**FOSTORIA SPLASHPAD
ADA RESTROOM FACILITY
AND PUMP HOUSE**

KLEINFELDER JOB NO. 24001561.002A

ADDENDUM NO. 2

March 26, 2024

C-02

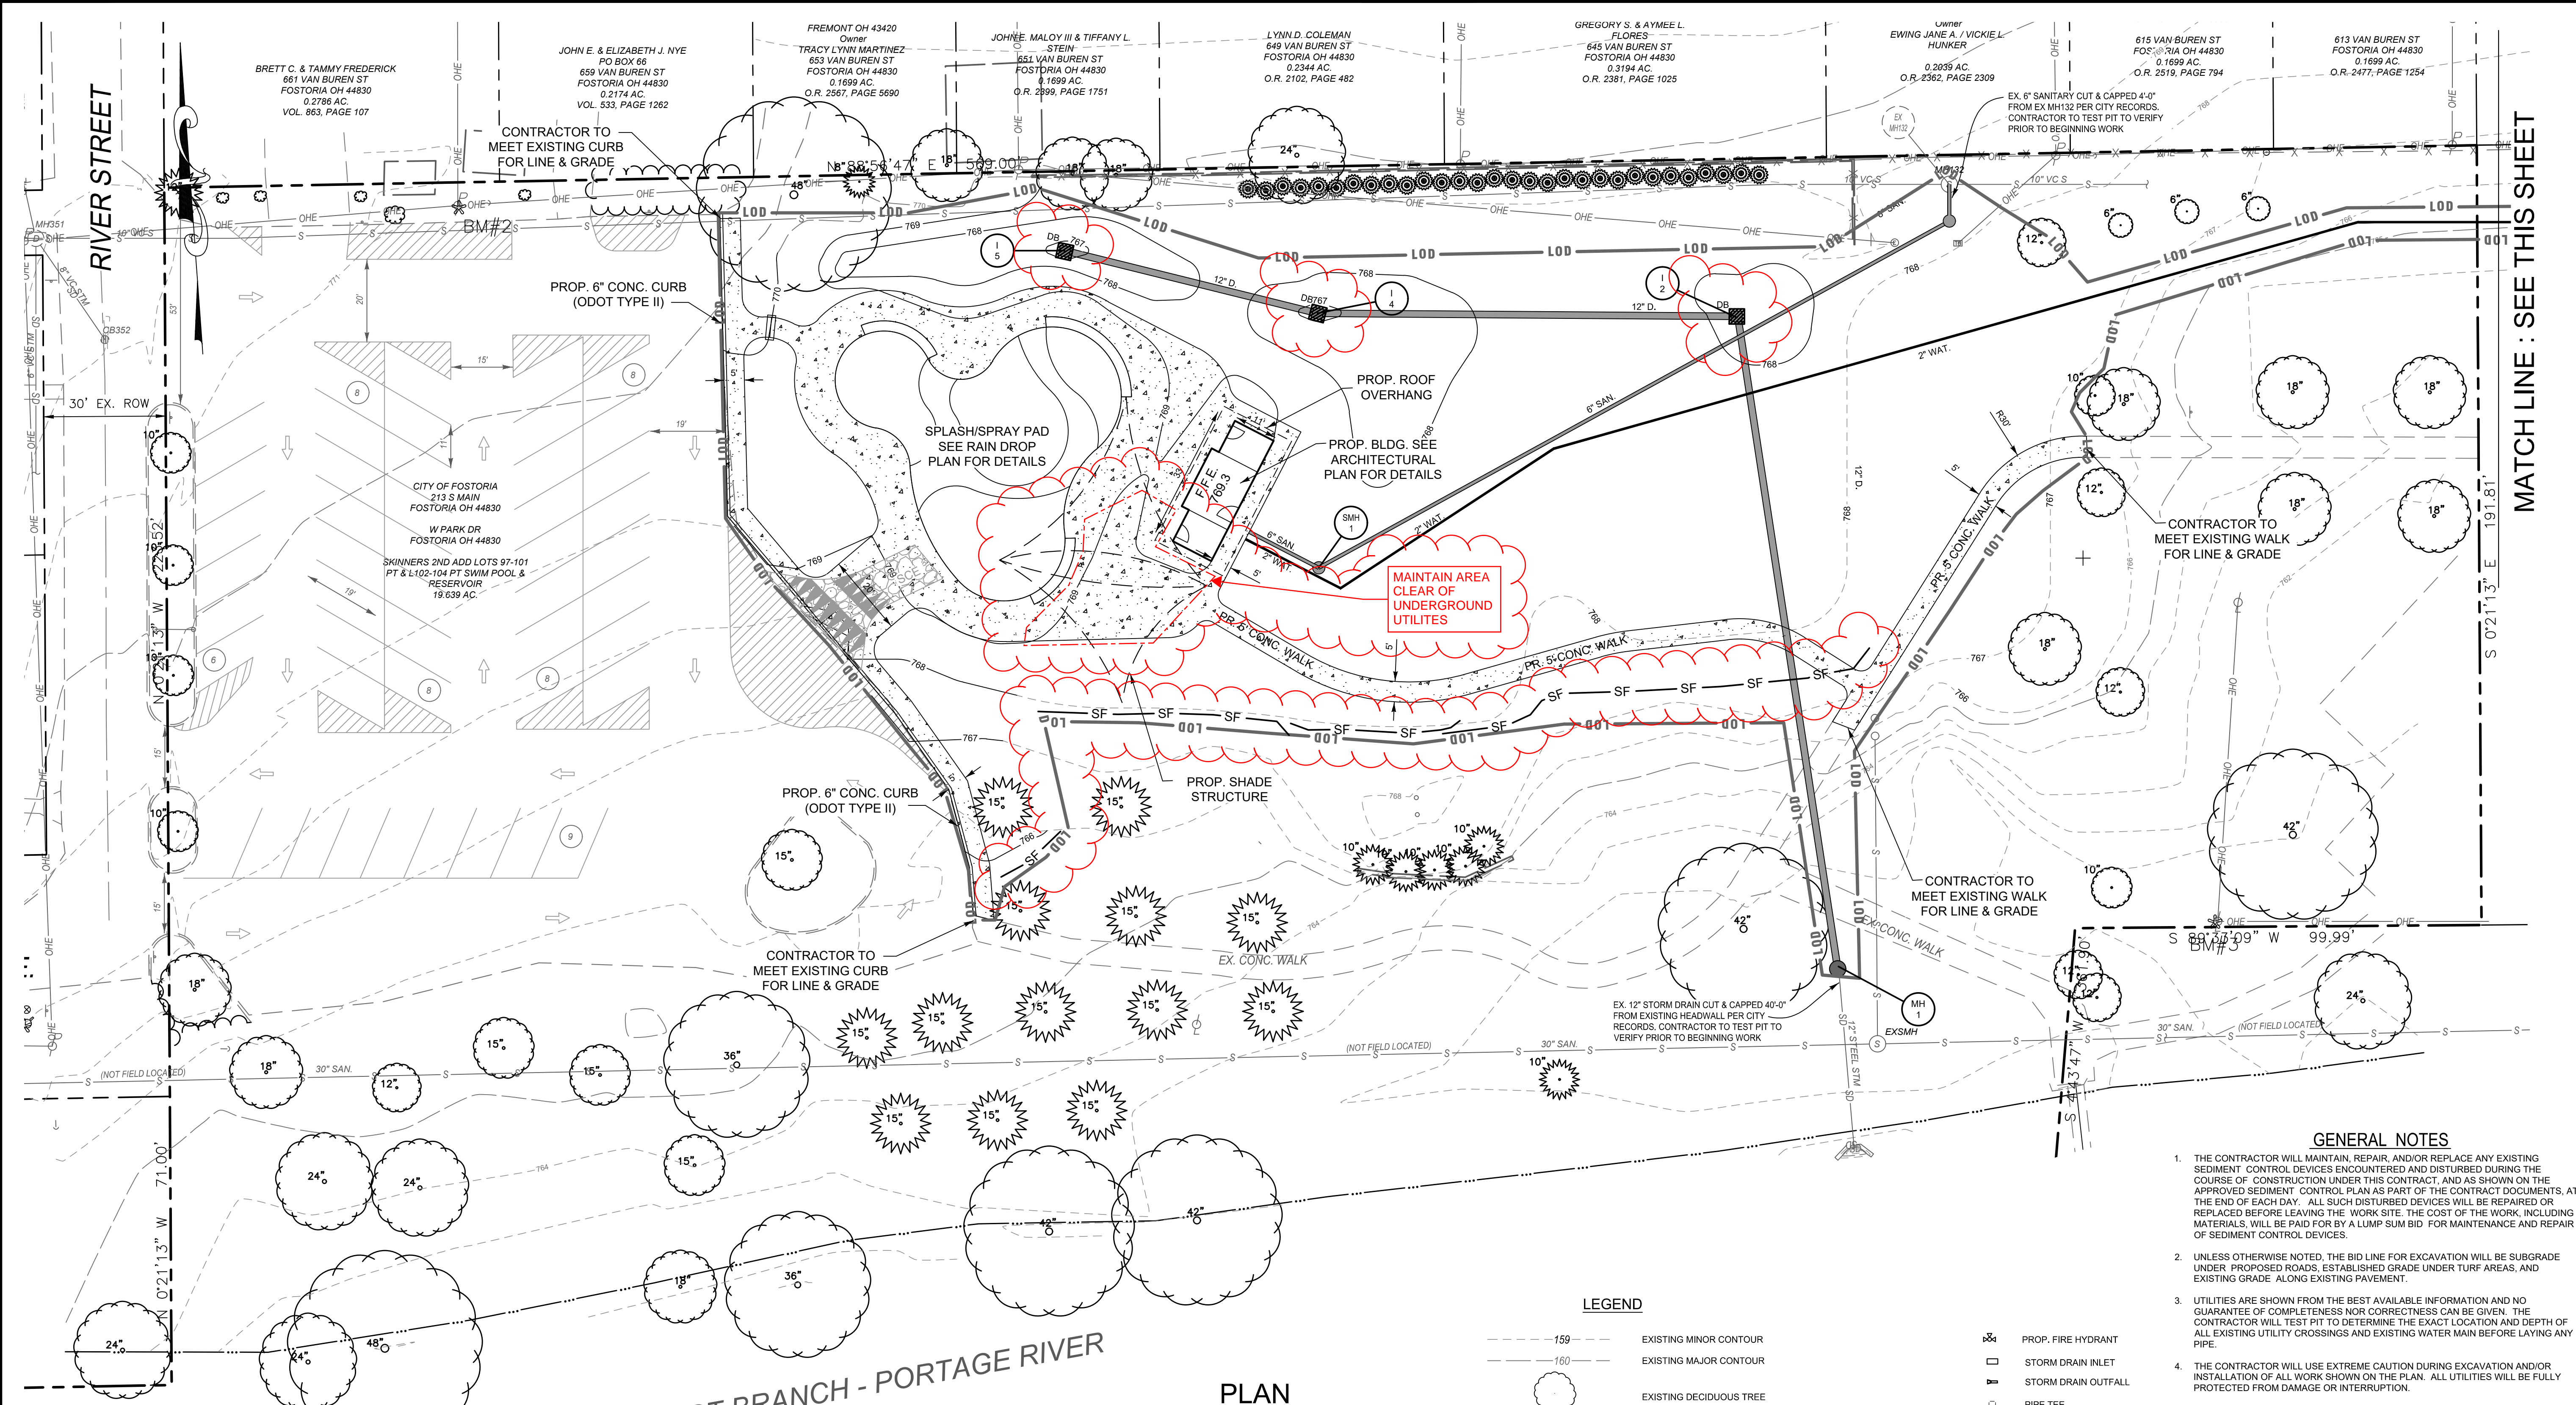
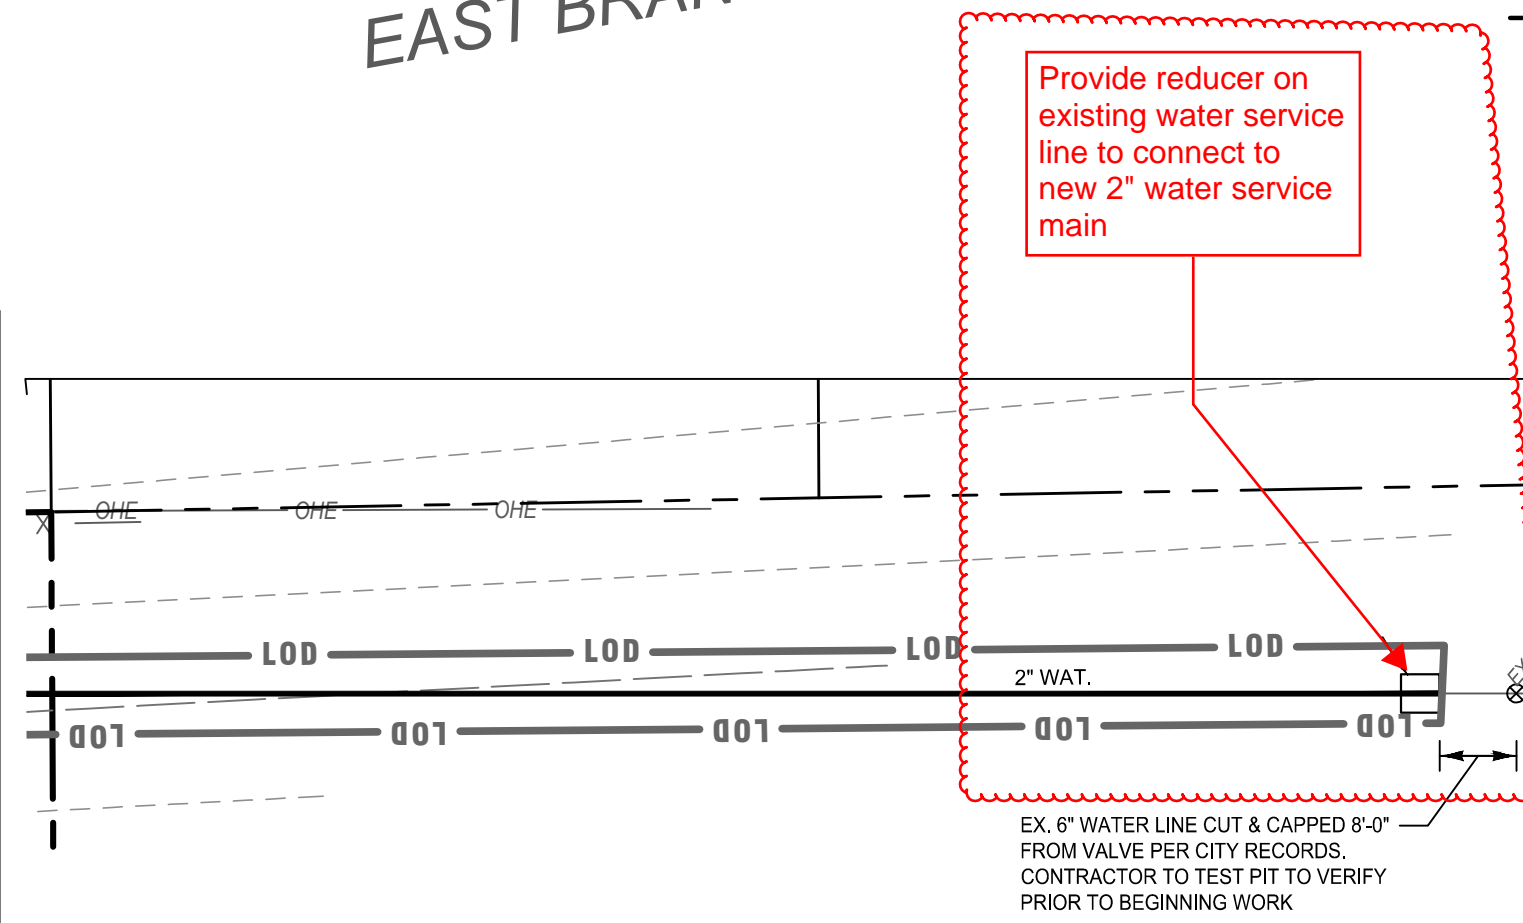
2. Question: There is proposed shade structure indicated on the drawings. Is this structure provided as part of this bid and if so, is there a specification? *Response: The proposed shade structure noted on the drawings is intended for a future addition and not part of this project. The area beneath this structure, to the extents possible, should be kept clear of underground utilities to allow for future foundation installations. See revised C-02.*

- A. ADDED erosion control notes and locations.
 - B. ADDED note indicating sidewalk area to be kept clear of underground utilities for future shade structure.

- C. REVISED water service connection near N. Vine St.
4. Sheet C-09 (issued herein)
 - A. ADDED new drawing.
5. Sheet E001 (reissued herein)
 - A. REVISED Specifications.

ELECTRICAL SITE POWER AND LIGHTING PLAN
SCALE: 1/8" = 1'-0"

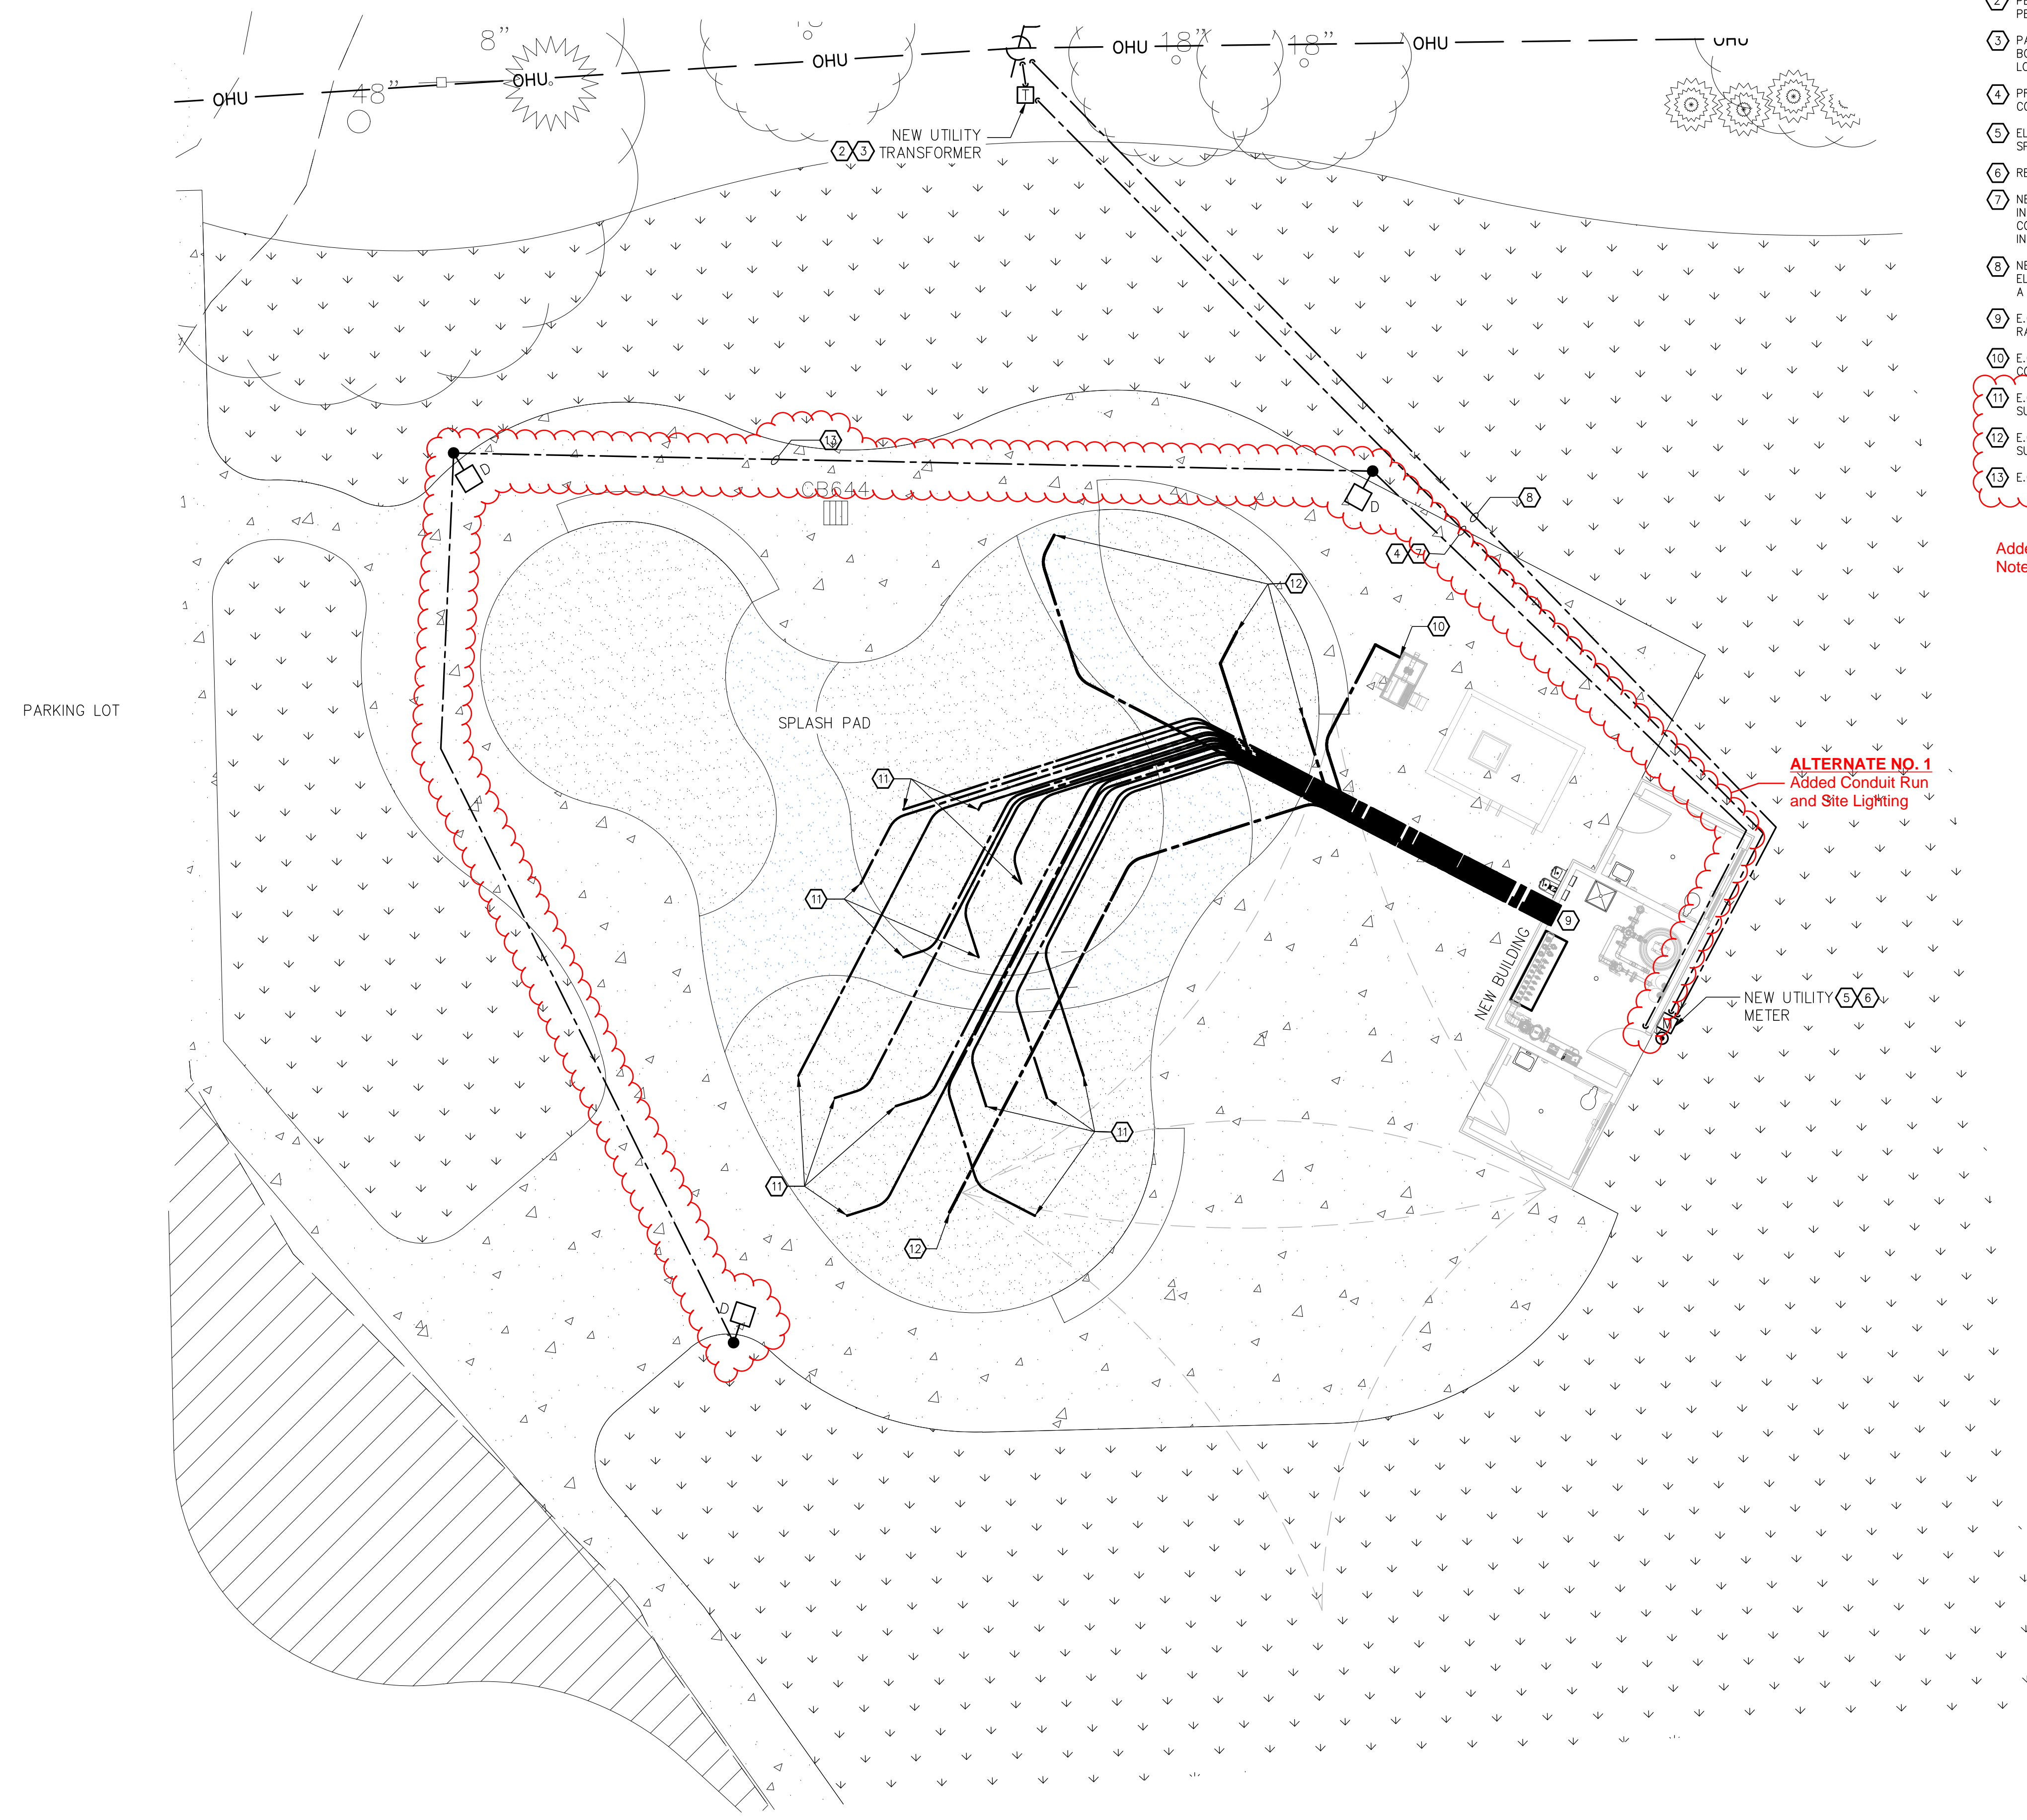
7. Sheet E102 (reissued herein)
 - A. REVISED sheet notes 11 and 12.
 - B. ADDED sheet note 13 for Bid Alternate 1.
 - C. ADDED Bid Alternate 1 site lighting and conduit.

ALTERNATE NO. 1
Added Conduit Run
and Site Lighting
